1320 East Pine

REVOLVE
DRB RECOMMENDATION MEETING / **SDCI** #3033207-LU / 27 JAN 2021

RECOMMENDATION RESPONSE SUMMARY

DETAIL PLAN - COMMERCIAL SPACE

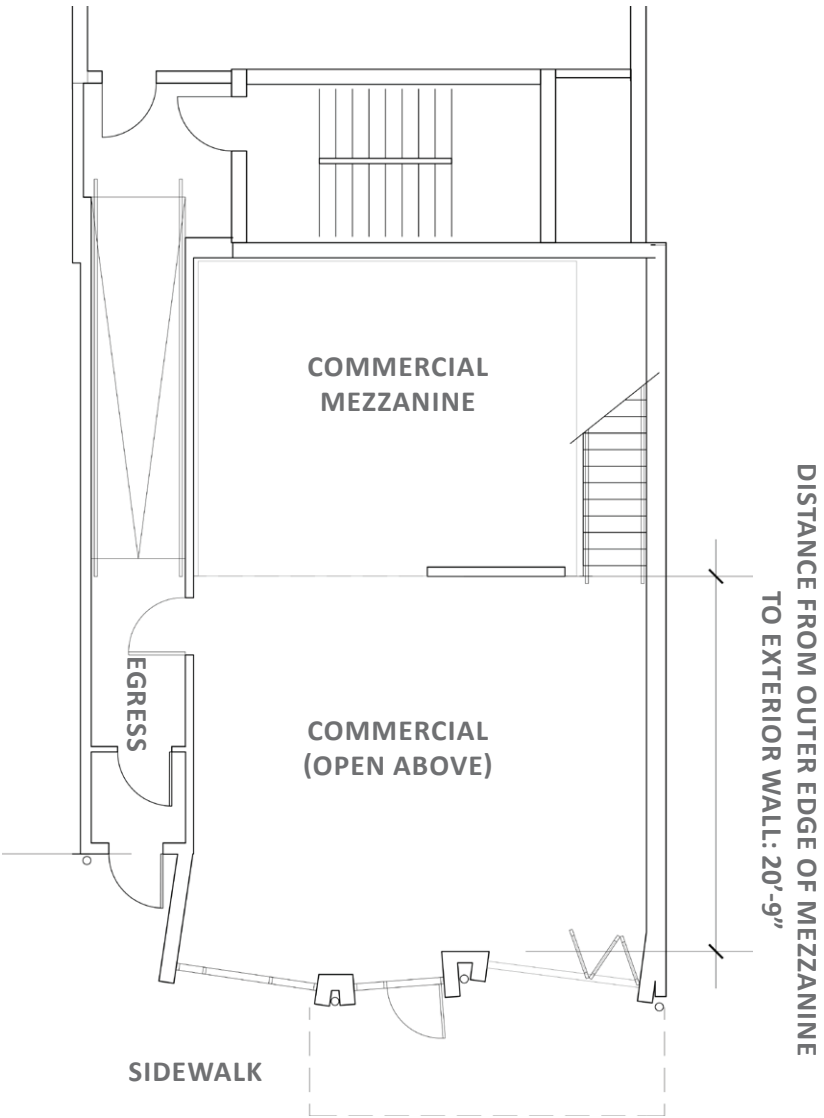
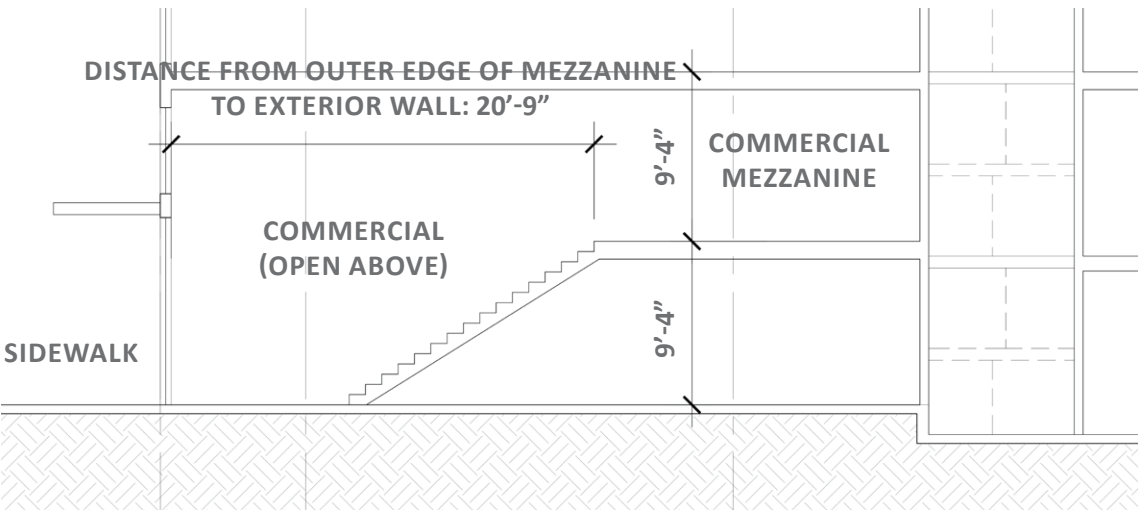
PROPOSED: Locate outer edge of mezzanine floor more than 20 feet (20'-9") from the exterior wall facing a principal pedestrian street.

Dimensionally, the commercial space is fairly tall and deep. The layout is such that the addition of a mezzanine to the rear of the space works well functionally for a variety of potential tenants, even though it is below the typical floor-to-floor height threshold of 13 feet. By moving the outer edge of the mezzanine 5 feet further back beyond the code required 15 foot minimum setback required for departure (20'-9"), the visibility of the mezzanine is diminished from the exterior. The recessed mezzanine helps the commercial space read as a tall two-story volume from the street to help establish an urban presence, while still offering functionality that will help to draw a high quality commercial tenant to the neighborhood.
